150 Richmond Street Revised Concept Plan Summary

I-195 Redevelopment District Commission Meeting
November 9, 2022

Revised Concept Plan Submission

Program: 212,000 sf lab, anchored by RISHL

Street Activation & Entries

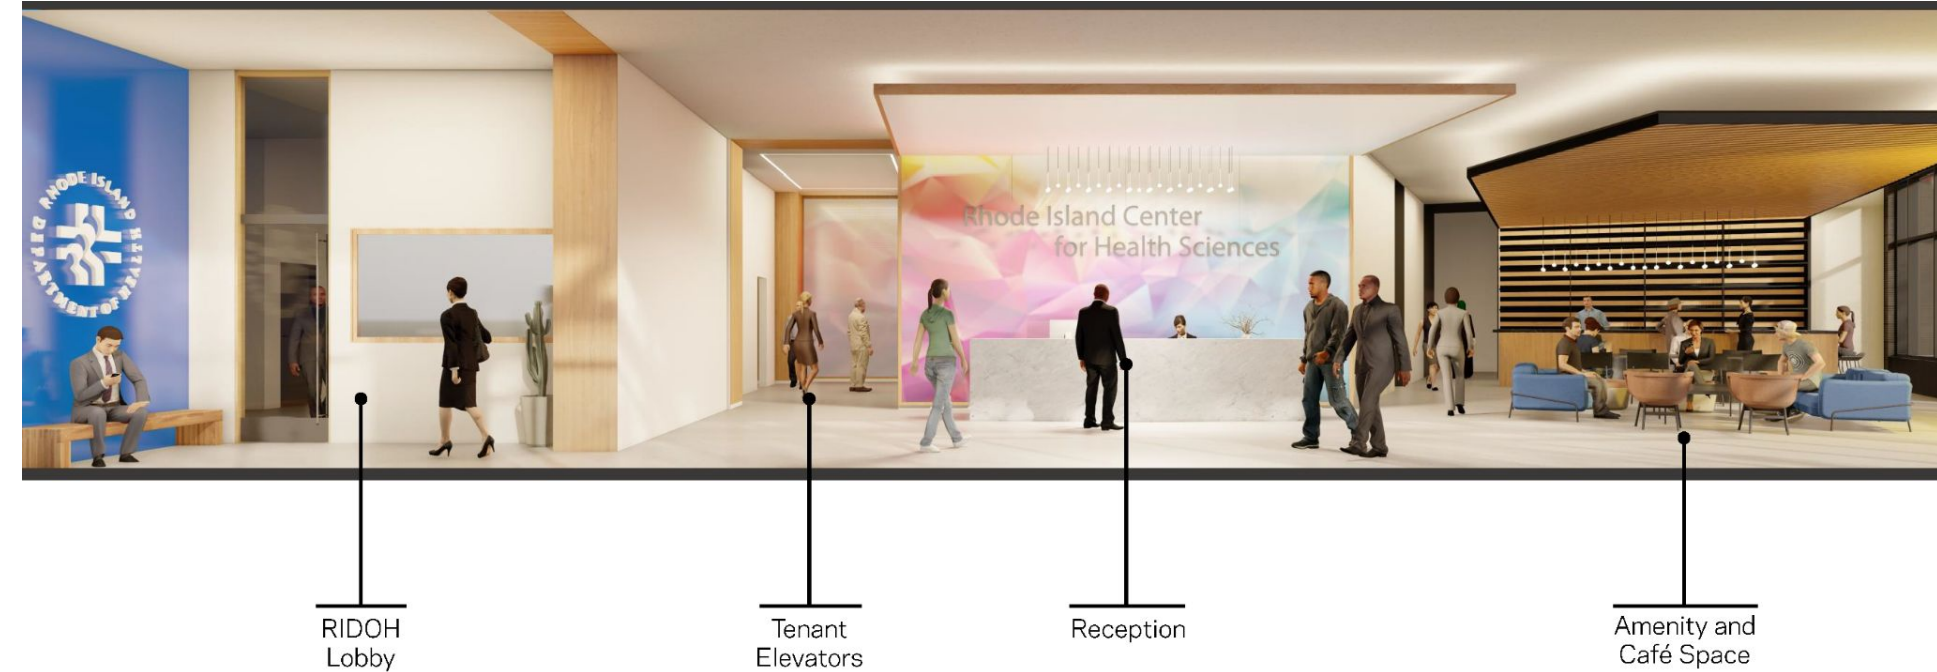
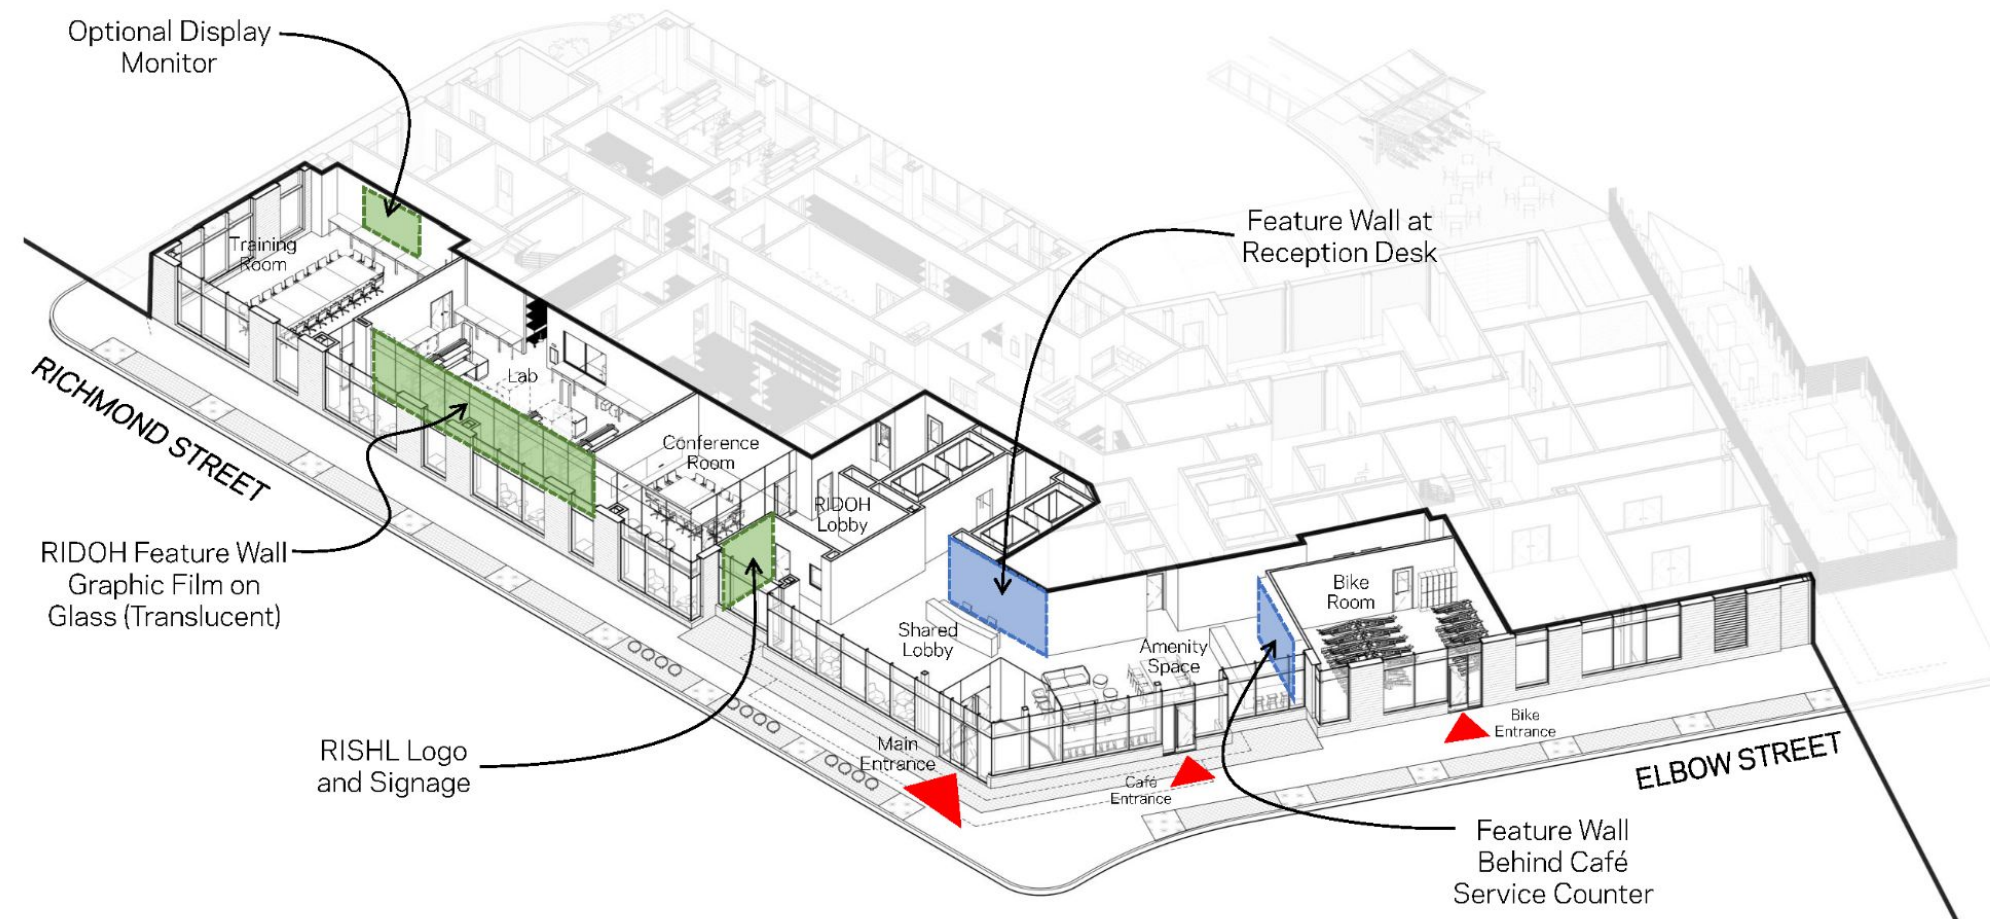
- Explore the possibility of separate front doors for RIDOH and/or the retail/amenity space, in order to more fully activate the public realm, especially along Richmond Street.
- Explore the introduction of more entryways to order to activate the street frontage.
- The Elbow Street frontage is mostly back-of-house spaces. Add interior bike parking to that edge to help activate the sidewalk.

- **Improvements to the ground floor plan include:**
 - **Enclosed bike room with direct connection to lobby/cafe/amenity space**
 - **Dedicated second door to the cafe/amenity space**

Rear Facade Expression & Materials

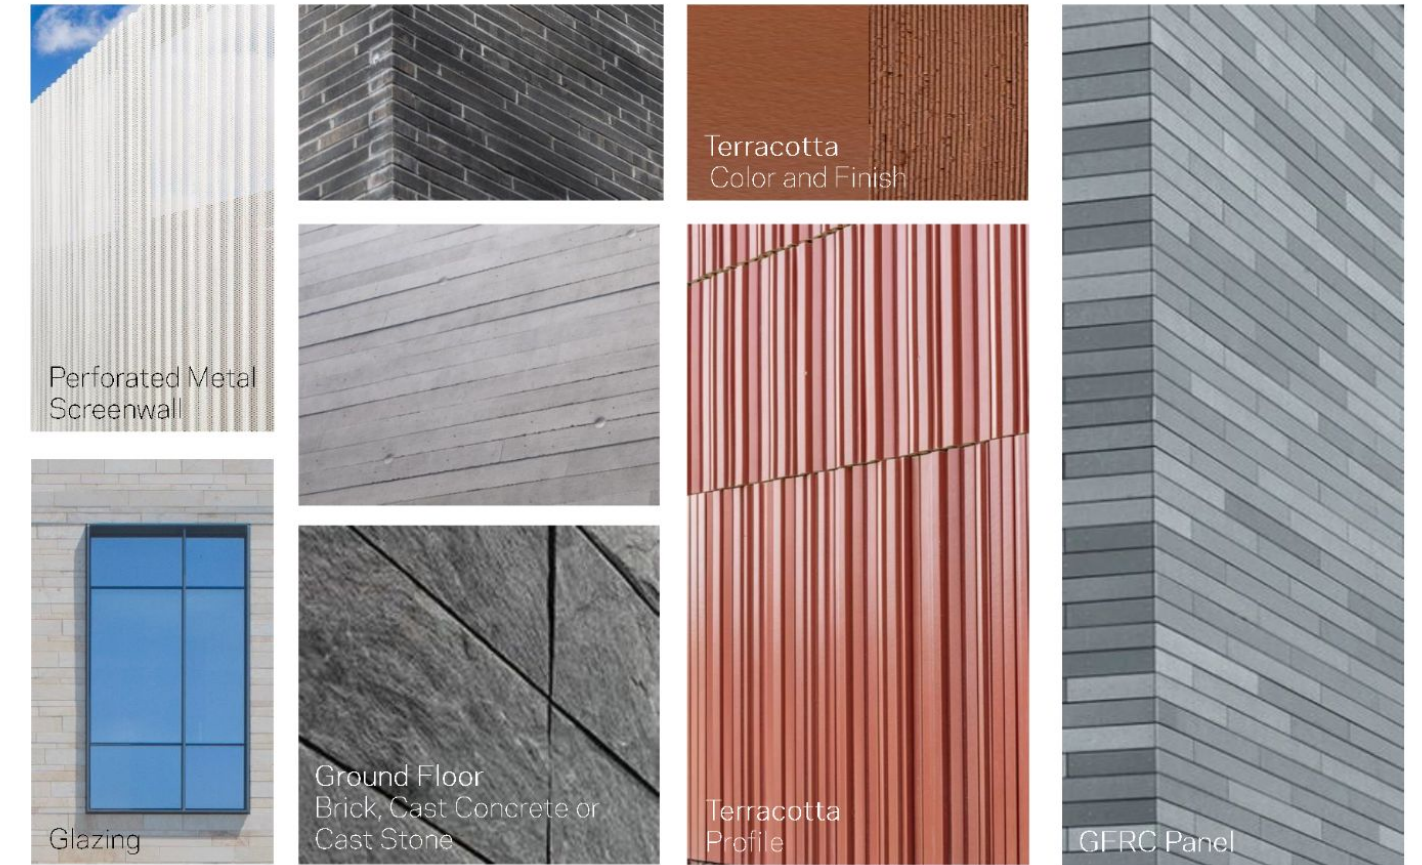
- While the Richmond and Elbow Street facades will be the priority over the long-term, the rear building facade will also be visually prominent until nearby parcels are developed.

- The design review supports the decision to differentiate the front and back of the building, both because it helps break down the mass of the building and because the different facades convey the differences in function (lab vs. office)
- While the new rendered views provide a better understanding of how the rear of the building will look from Clifford Street and the 225 Dyer pedestrian pathway, the design review panel thinks the expression is too utilitarian-looking and lacks scale and texture.
